ADDENDUM NO. 2

DATE: February 24, 2023

RE: Dickinson Park Sports Fields Renovations
Project No.: 21-1558

Drawings: (all revisions have been clouded and tagged with a delta-2)

HARD COPY IS INTENDED TO BE 24" x 36" WHEN PLOTTED (SCALE(S) INDICATED AND GRAPHIC QUALITY MAY NOT BE ACCURATE FOR ANY OTHER SIZE)

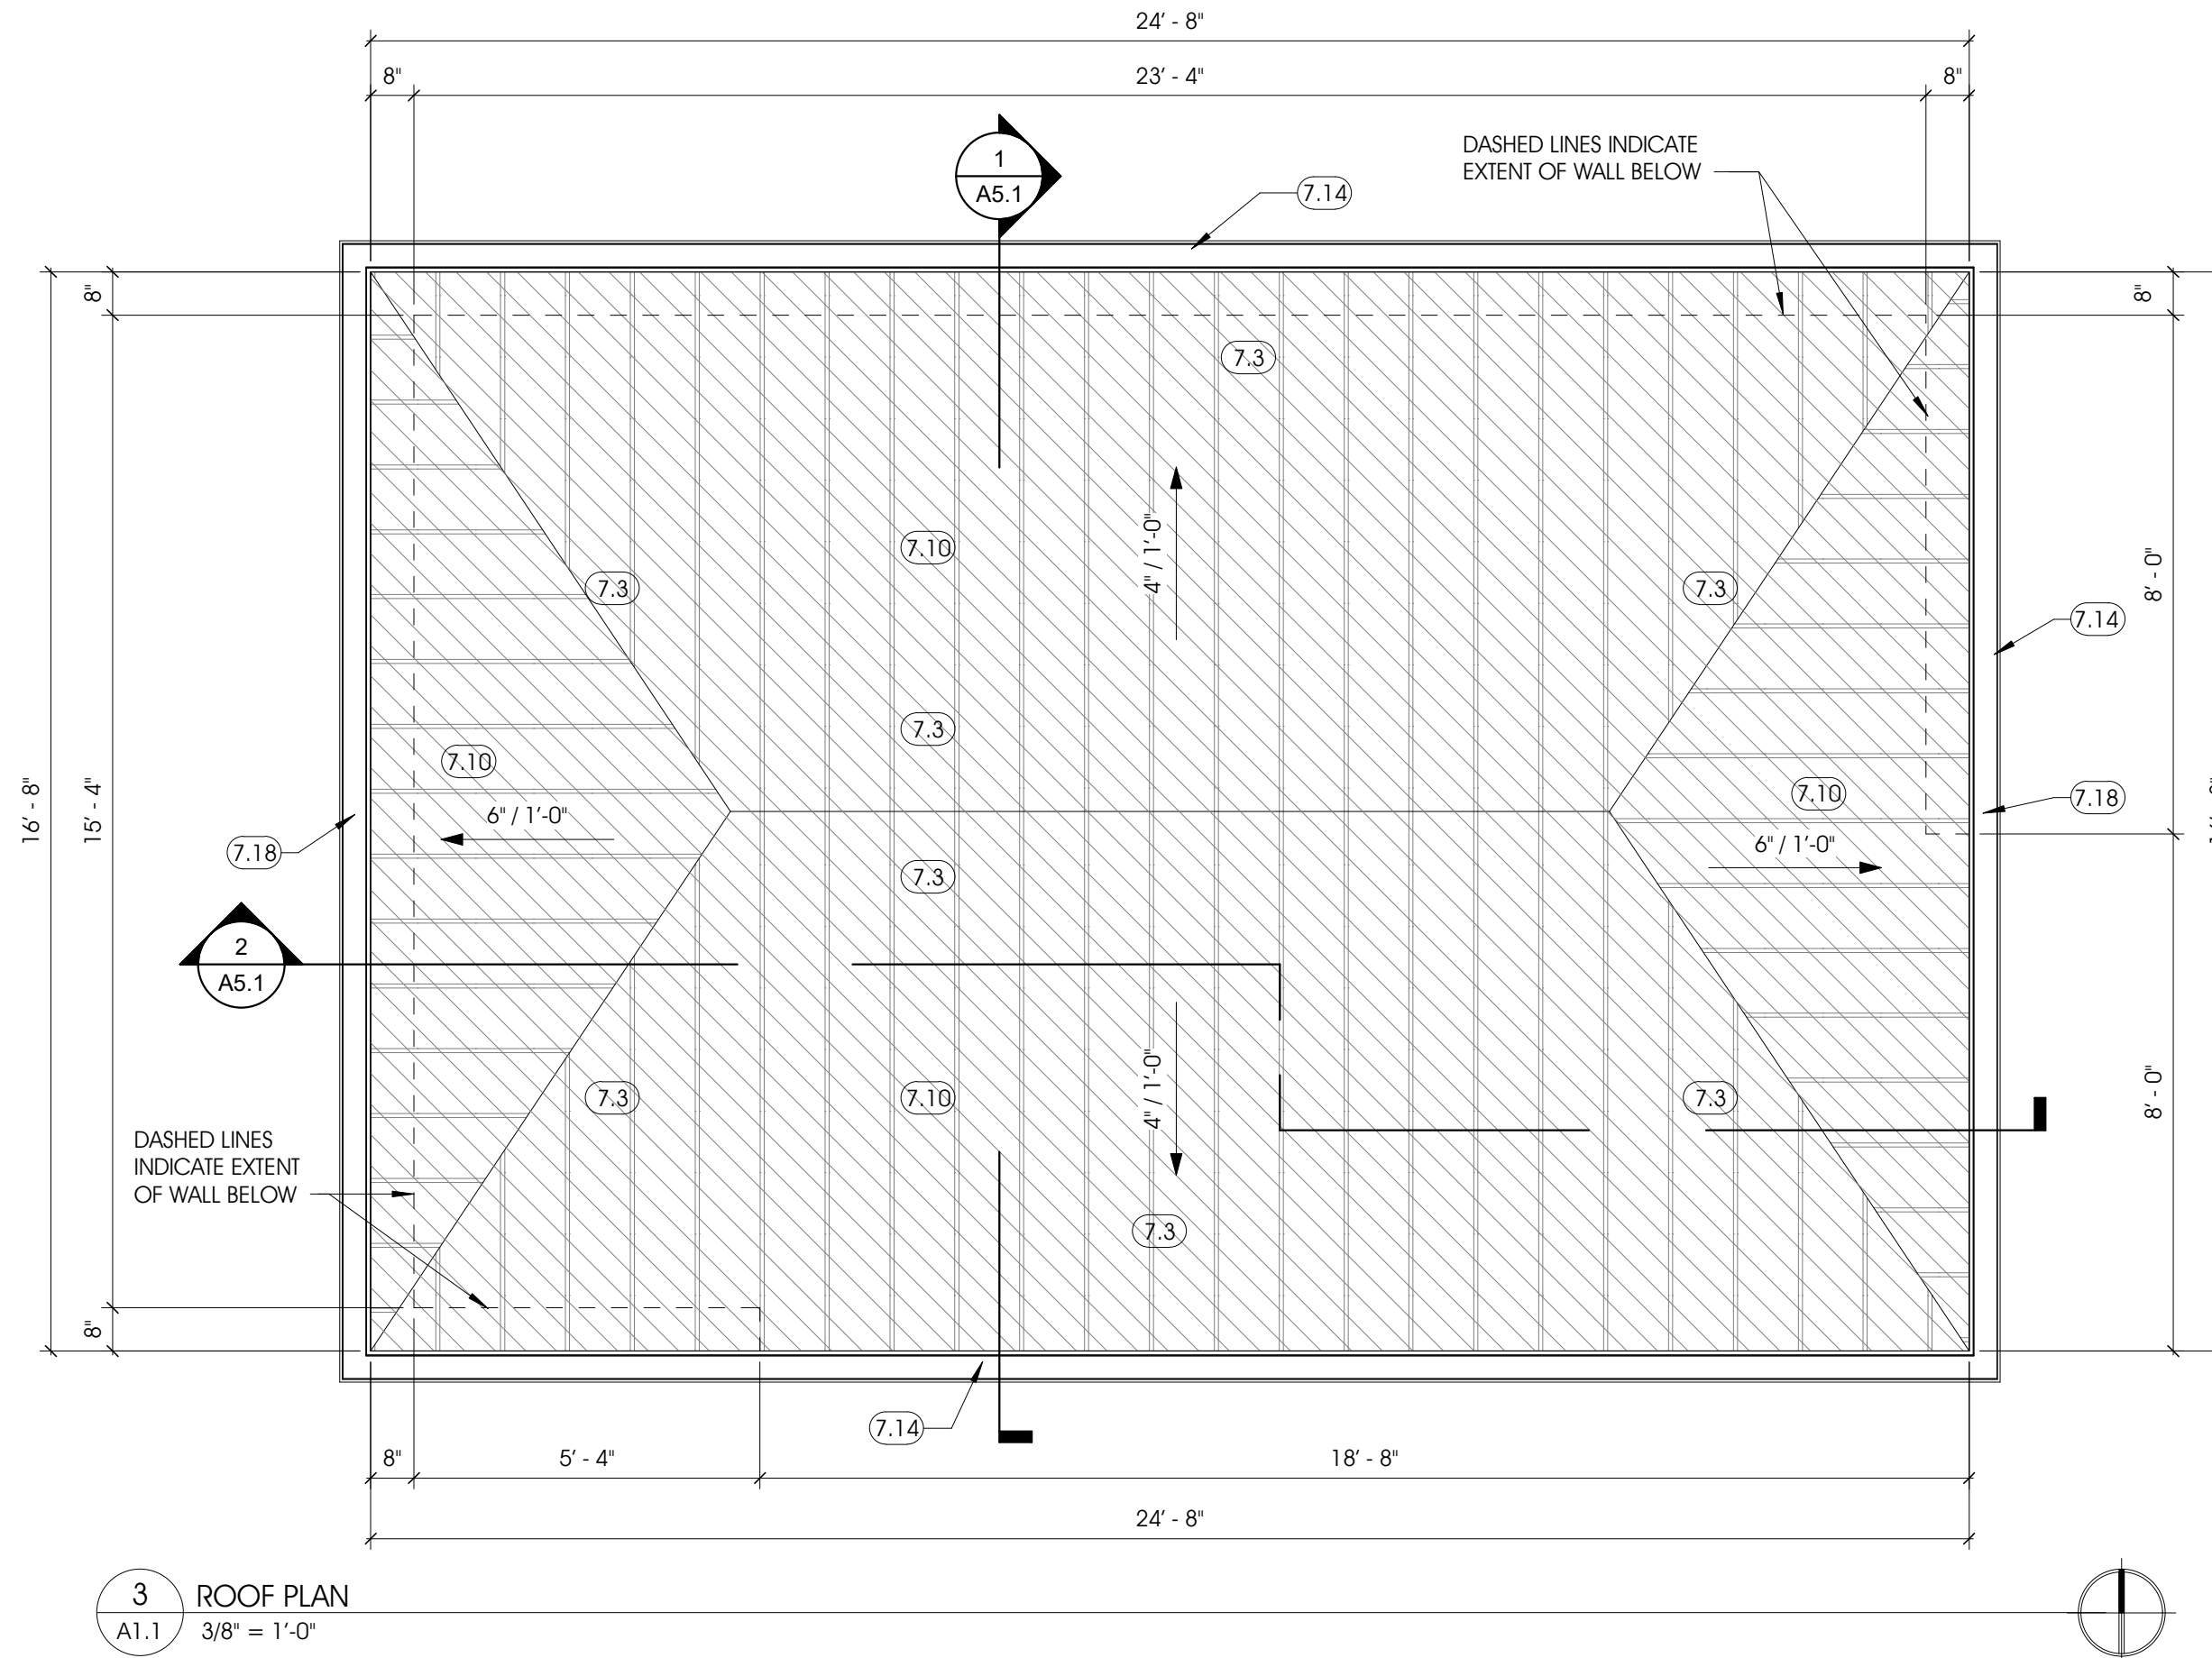
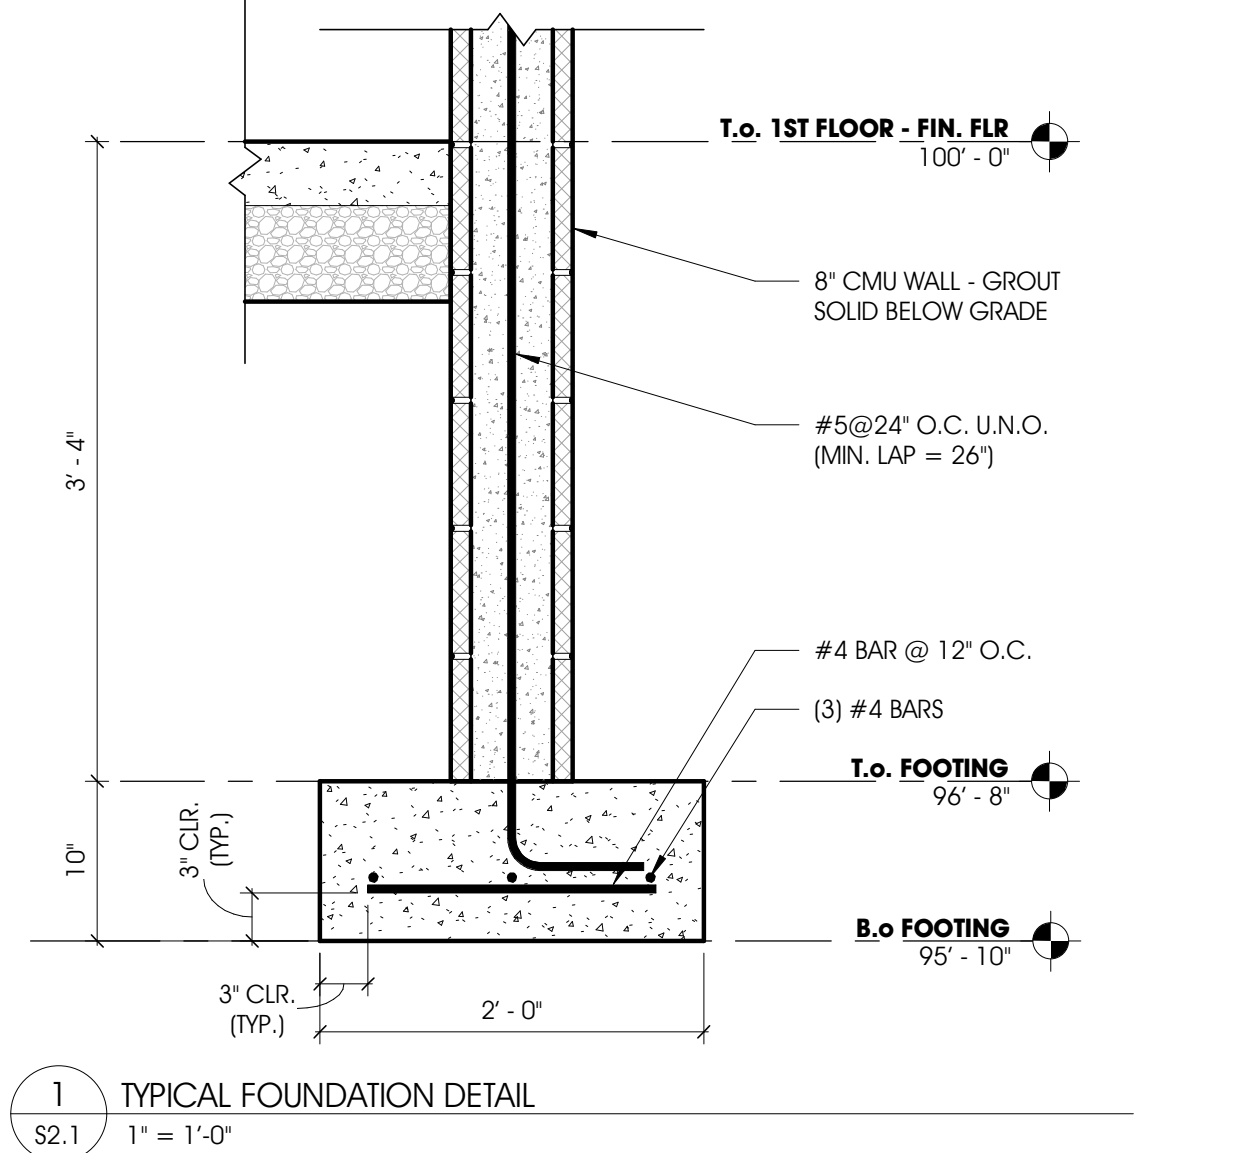
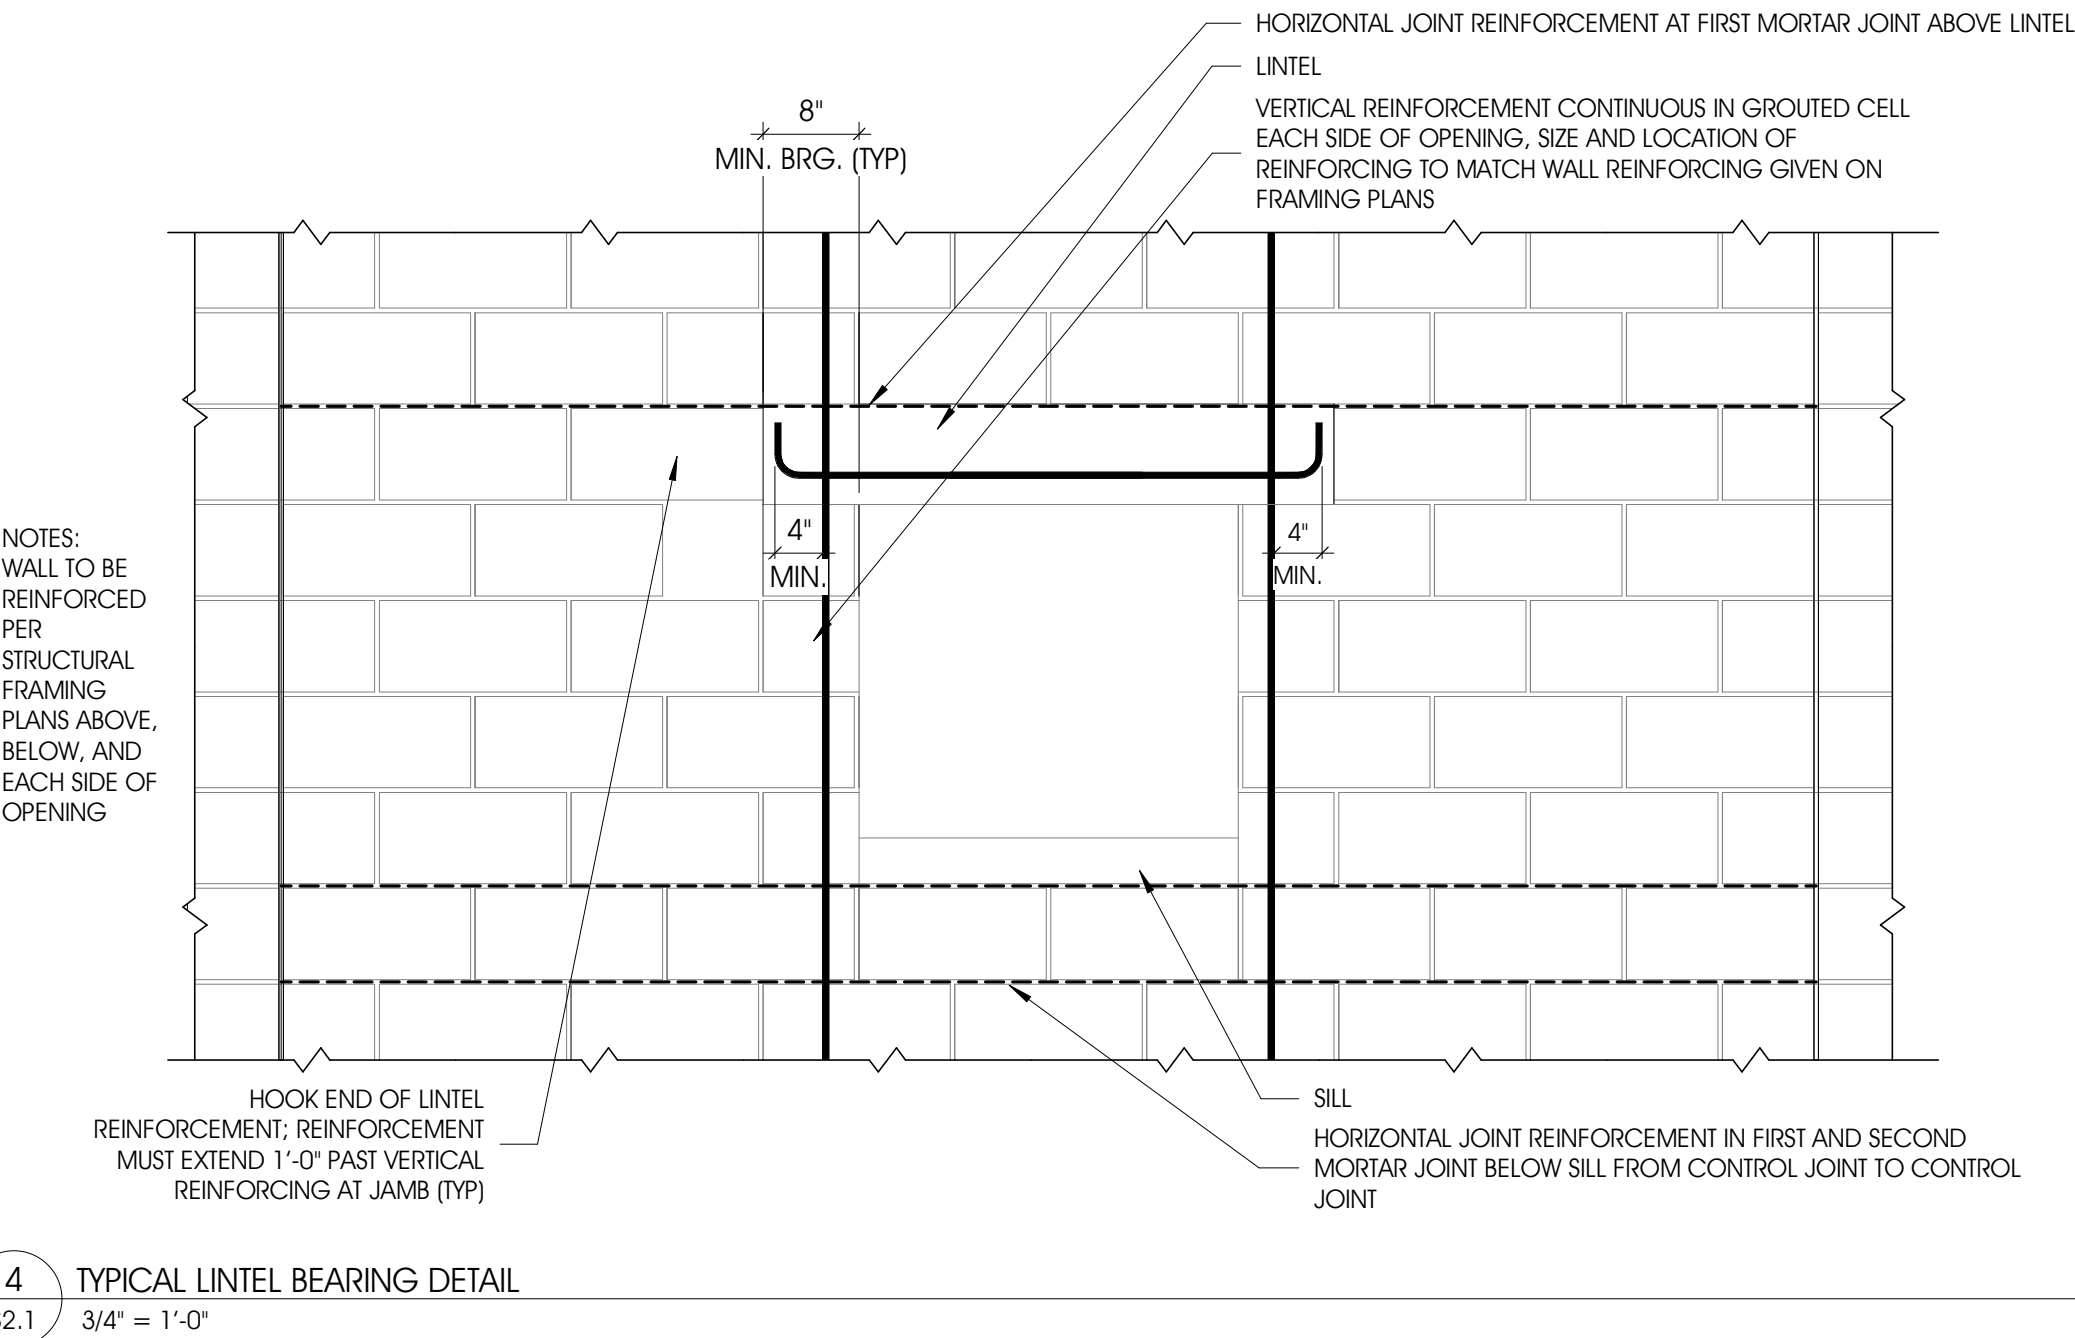
- d. Added Lintel Sections detail drawings.
 - e. Minor revisions to General Notes C and F.
13. Alternate 1, Sheet S2.1
- a. Added Sheet S2.1; previously omitted by error

- b. Added top of CUM Wall, Roof Rafter tie-down/anchoring details (drawings 2/S2.1, 3/S2.1, 5/S2.1, 6/S2.1)
 - c. Added Ledger Detail (drawing 8/S2.1)

- d. Added Detail @ Half-Wall Framing (drawings 9/S2.1 and 10/S2.1)
14. Alternate 1, Sheet A1.1
- a. Revised dimension string in drawing 2/A1.1 (see revision bubble)
